Minutes of an ordinary meeting of the Development Support Special Committee held in the Council Chamber of the Administration Centre, 19 King Edward Street, Ulverstone on Monday, 14 November 2016 commencing at 6.00pm

42/2016 Residential (multiple dwellings x two) – variation to side boundary setbacks and building envelope at 17 Main Street, Ulverstone – Application No. DA216054

<i>DEVELOPMENT APPLICATION NO.:</i>	DA216054
<i>PROPOSAL:</i>	Residential (multiple dwellings x two) – variation to side boundary setbacks and building envelope
<i>APPLICANT:</i>	Dr Sandhya Sharma
<i>LOCATION:</i>	17 Main Street, Ulverstone
<i>ZONE:</i>	General Residential
<i>PLANNING INSTRUMENT:</i>	<i>Central Coast Interim Planning Scheme 2013</i> (the Scheme)
<i>ADVERTISED:</i>	4 October 2016
<i>REPRESENTATIONS EXPIRY DATE:</i>	19 October 2016
<i>REPRESENTATIONS RECEIVED:</i>	Two
<i>42-DAY EXPIRY DATE:</i>	9 November 2016 (extension of time until 21 November 2016)
<i>DECISION DUE:</i>	
<i>PURPOSE</i>

NORTH 	DRAWING SITE WORKS		DRG No. P2 / -
	DEVELOPMENT PLANS		
	DATE 27/9/16	JOB No. 0816-18	
SCALE 1:200

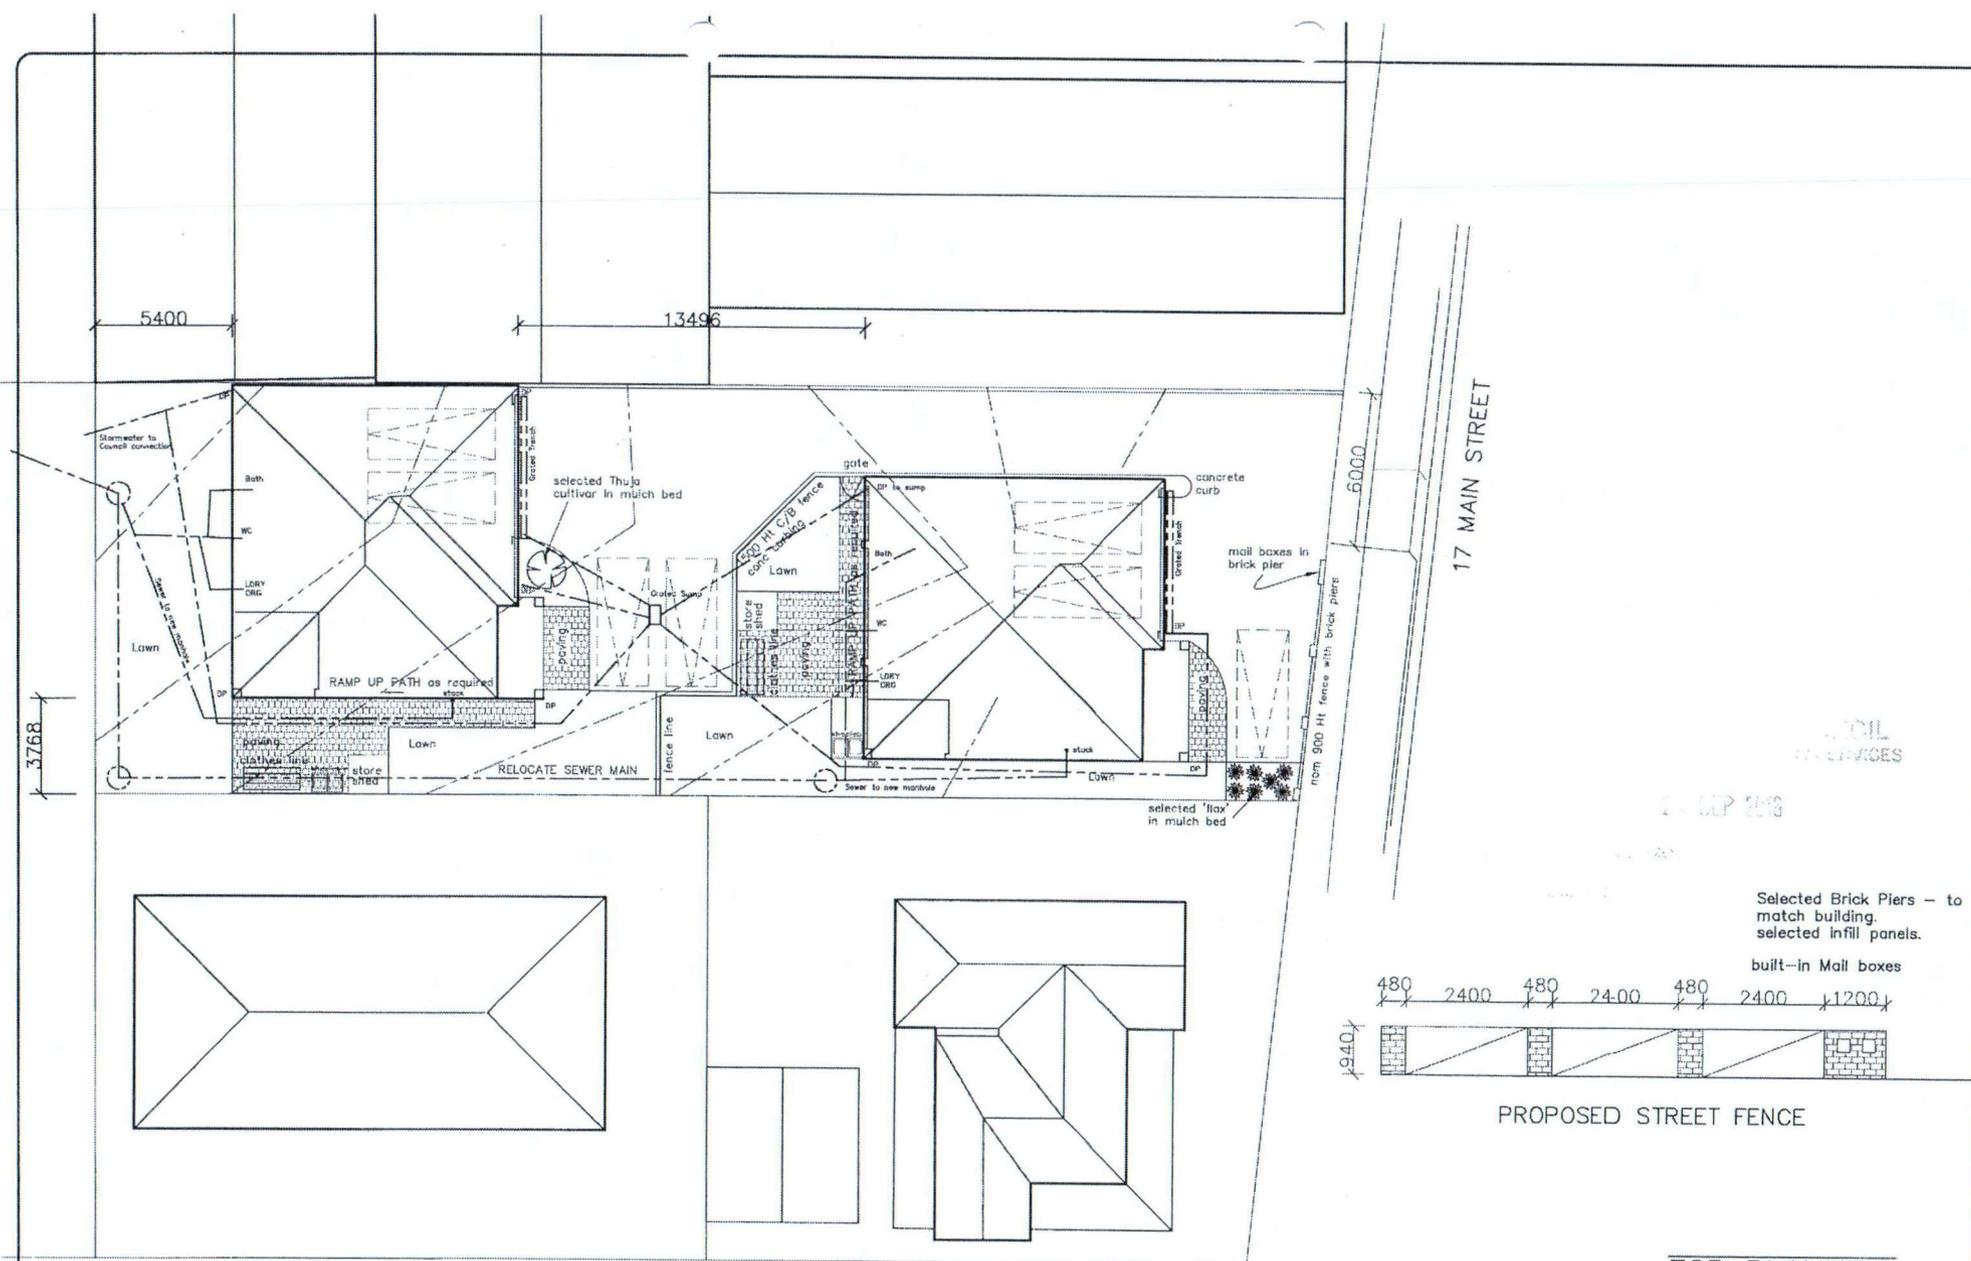
- R1 The existing 3.6m wide access shall be widened (to the west) to a 6.0m wide access generally as shown on the Tas Laughlin Site Works Development Plans Drawing No. P2 of Job No. 0816-18 dated 27 September 2016 (copy enclosed);
